# Recall Bulletin 190318REV

Fleetwood Flair  
manufactured  
1/31/2019  
through  
2/28/2019

Holiday Rambler  
Admiral  
manufactured  
1/30/2019  
through  
2/28/2019

Inspection /  
Correction of  
Battery Hold-  
Down Straps  
and Strap  
Mounting  
Hardware

**Figure 1**

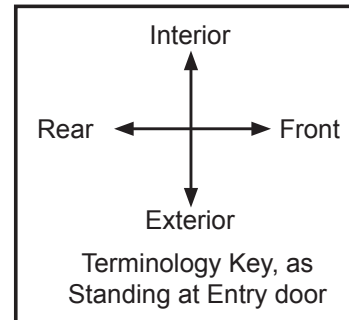
4. With the entry step retracted and auxiliary battery disconnect off, open the entry door. Access the auxiliary battery compartment by removing the (2) screws from the cover on the lower step with a wide, flat blade screwdriver. Set the screws aside for later reinstallation.
5. Inspect the battery compartment area for the battery hold down strap orientation. Refer to Figure 1 for a terminology key, and to the photos in Figures 2-4 on Page 3 as examples of both battery hold down strap scenarios.
  - If the battery hold down straps are oriented from the front of the coach towards the rear of the coach, take several clear photos of the battery compartment area and reinstall the lower step cover. Submit a claim with 6079-11, for Inspected/Not-Defective.
  - If the batteries have hold down straps oriented towards the exterior of the coach, proceed to Step #6 to continue the inspection.

**Figure 2**  
Correct Battery Strap Installation

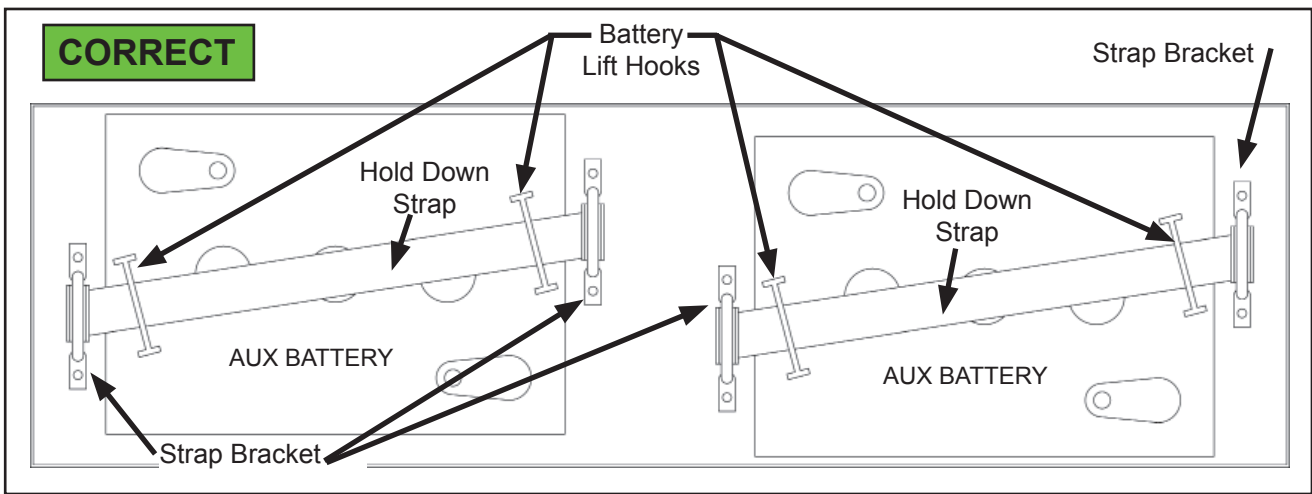
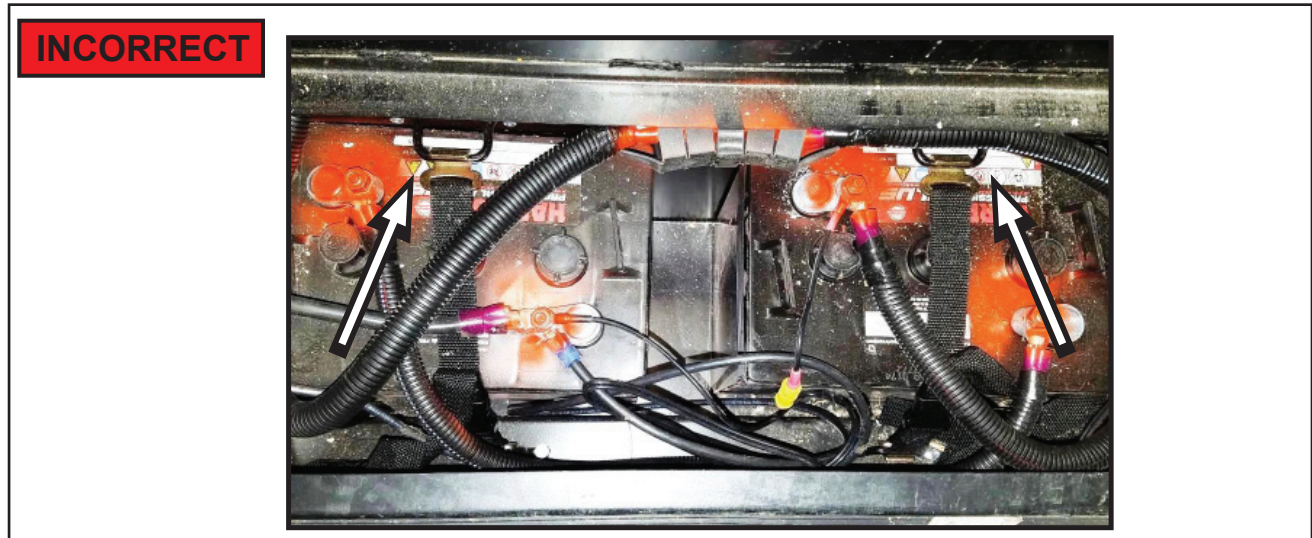
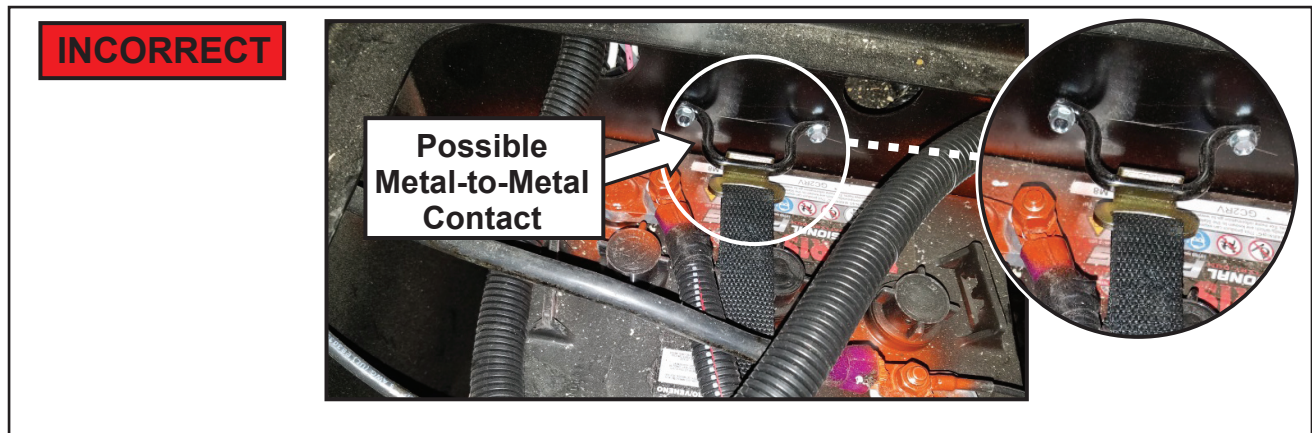
On motorhomes affected by this recall, the auxiliary batteries, located inside the entry step compartment, were installed with hold-down straps attached with mounting brackets; both the straps and the mounting brackets have metal components and were mounted in a manner that could allow the batteries to make contact between the battery terminals and the hold-down straps and/or their mounting brackets.

If the metal on the battery hold-down strap or the metal hold-down strap mounting bracket contacts the battery terminal, erratic electrical issues, smoke, or fire could result, posing the risk of property damage, personal injury or death.

**Figure 5**  
**Arrows indicate original locations of the (4) battery hold down strap mounting brackets**

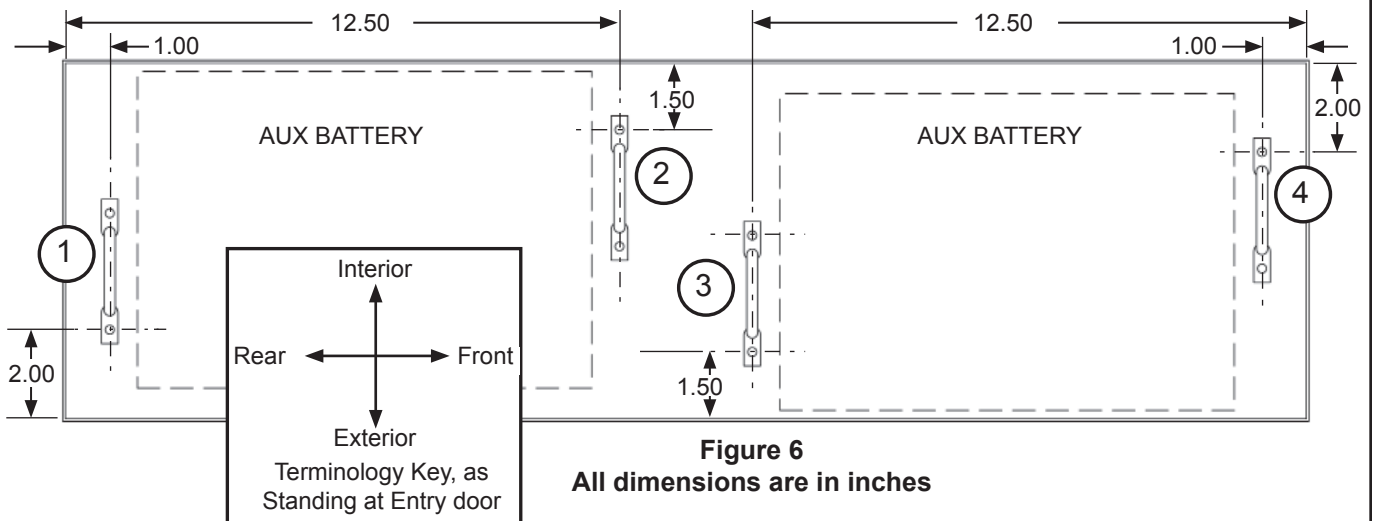
7. Locate and release the buckle on both battery hold down straps. Carefully unhook the straps from their mounting brackets and remove them from the battery compartment area. Set the straps aside for later reinstallation.
8. Referencing Figure 5, use a 5/16" hex head driver bit to remove the battery hold-down strap mounting brackets and attachment screws. There are (2) brackets mounted on the interior vertical surface of the compartment and (2) brackets mounted on the bottom surface of the compartment. Set aside all of the brackets and screws for later reinstallation.
